Appl. No. 10/058,015
Amdt. dated February 17, 2004
Reply to Office Action of Sept. 17, 2003

ANNOTATED SHEET SHOWING CHANGES

FIG. 2

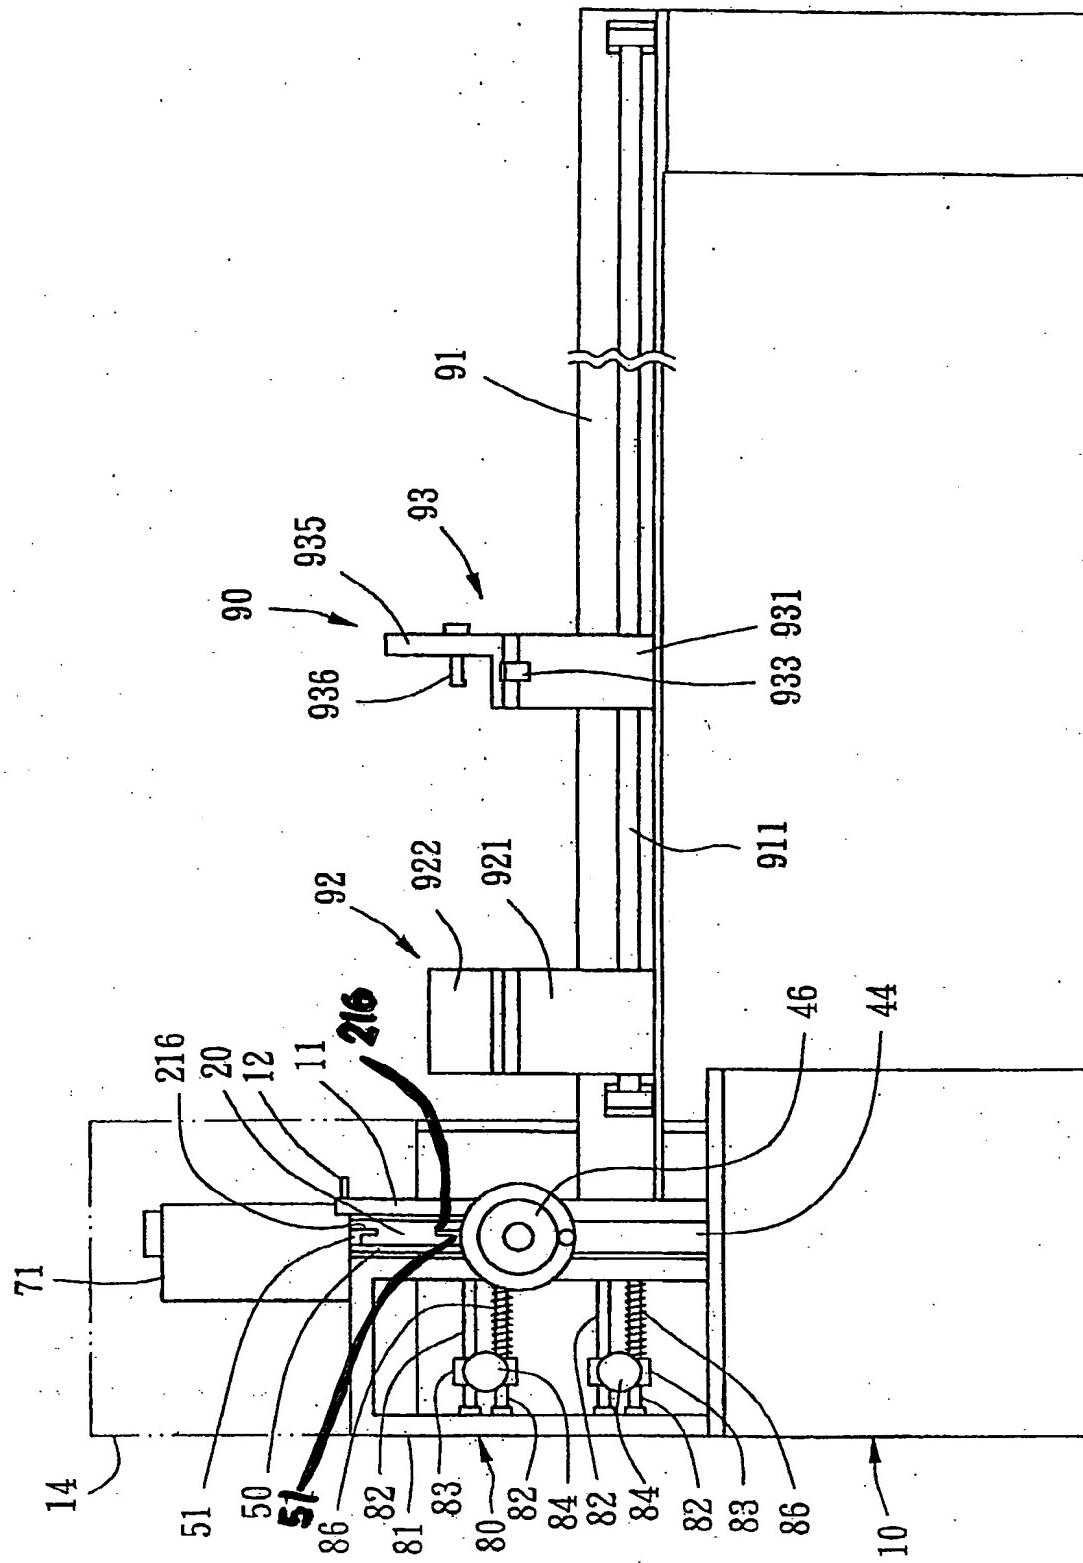
1. canceled claim 11 to eliminate the "scale length" feature;
2. identified element 86 on page 7, line 9 of the specification; and
3. identified elements 317, 52, 53, 54, 501, 61, 62 and 63 in the drawings and new Fig. 9.
